State of California – A Natural Resources Agency
OFFICE OF ENERGY INFRASTRUCTURE SAFETY
715 P Street, 15th Floor | Sacramento, CA 95814
916.902.6000 | www.energysafety.ca.gov

NOTICE OF NON-PERFORMANCE

INSPECTION REPORT

Electrical Corporation:	Pacific Gas and Electric Company
Report Number:	PAD_PGE_IAG_20260429_1158
Inspector:	Ivan Garcia
WMP Year Inspected:	2025
Quarterly Data Report (QDR) Referenced:	Quarter 4 (Q4)
Inspection Selection:	Energy Safety viewed the contents of the Q4 QDR and performed an analysis that resulted in the selection of the WMP initiatives and locations referenced in this report.
Relevant WMP Initiative(s):	8.1.7.2 – Open Work Orders – Distribution Tags
Date of Inspection:	April 29, 2026
City and/or County of Inspection:	Shingle Springs, El Dorado County
Inspection Purpose:	Assess the accuracy of Pacific Gas and Electric Company's QDR data, completeness of its work, and performance of WMP requirements.

General Image 1: Overall Structure	**General Image 2**: Structure ID

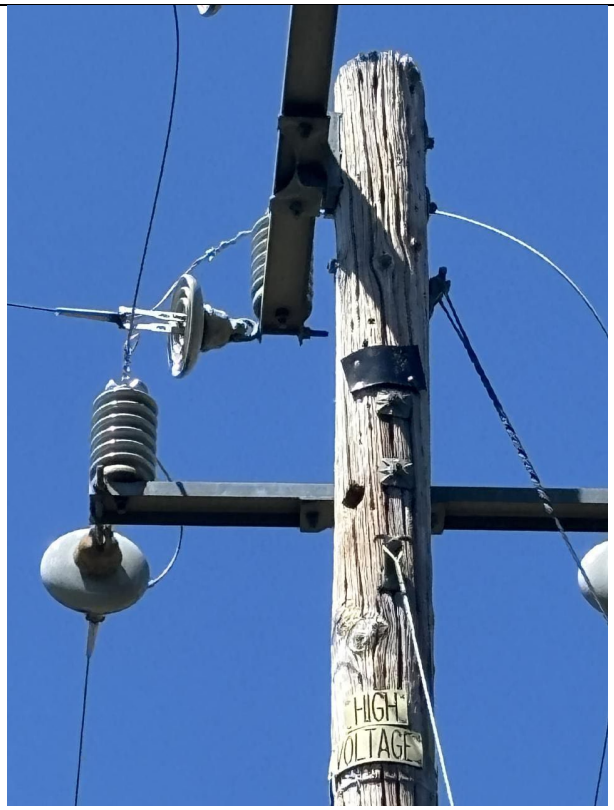
On Structure ID I121300969, Grid Hardening ID 119647028 at 3475-3501 Eastview Dr, Shingle Springs, CA, 95682, USA, 38.6737244554636, -120.930135465821, the inspector observed a woodpecker hole greater than one (1) inch in diameter and within two (2) inches of attachment hardware at this location. The inspector's observation is documented in Deficiency 1 photographs, which are attachments to this report. Photo numbers Asset Image 1, Asset Image 2, depict a woodpecker hole present near the attachment hardware and Item1IB1Img1-1, Item1IB1Img1-2, and Item1IB1Img1-3 are references used to evaluate the pole condition. In the 2025 Q4 Quarterly Data Report submission, PG&E reported that work on WMP initiative 8.1.7.2 – Open Work Orders – Distribution Tags was completed at this location.

1. A distribution tag created at the inspection location was cancelled and found not be "non-compelling per updated TD-2305M-JA02, Rev. 14" according to PG&E's distribution tag long text.
2. Inspector observed a woodpecker hole greater than one (1) inch in diameter and within two (2) inches of attachment hardware at this location.
3. Woodpecker holes greater than (1) inch in diameter and within two (2) inches of attachment hardware warrants pole reframe or replacement per PG&E document TD-2305M-JA02, Rev. 14.

Deficiency 1. Energy Safety observed that in implementing 2025 WMP initiative 8.1.7.2 – Open Work Orders – Distribution Tags, PG&E failed to complete work on an open work order – distribution tags on Structure ID 121300969, Grid Hardening ID 119647028 at coordinates 38.6737244554636, -120.930135465821. Energy Safety considers this non-performance to be in the Minor risk category. PG&E must complete a corrective action for this deficiency by 12 months of this notice.[1]
